Attachment 2
Applicant's Rationale Letter

817 St. Andrews St – PASSIVE HOUSE TRIPLEX

This summary is both a response to the *Pre-Application Review for 817 St Andrews* letter of September 28 2020 and a Design Rationale.

2. RESPONSE TO Pre-Application Review for 817 St Andrews.

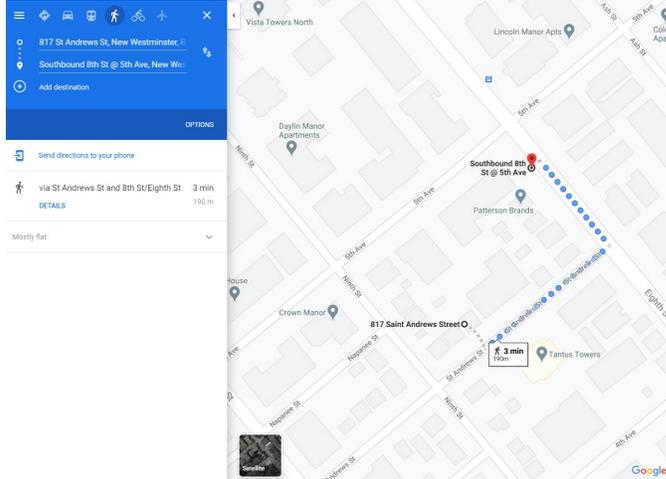
There is also an argument to be made against any parking requirement, despite zoning. Many people do not require vehicles nor desire them, yet have families or want larger units. The location near the arterial of 8th St provides for a short 190m walk to the bus stop on the same block. See below.
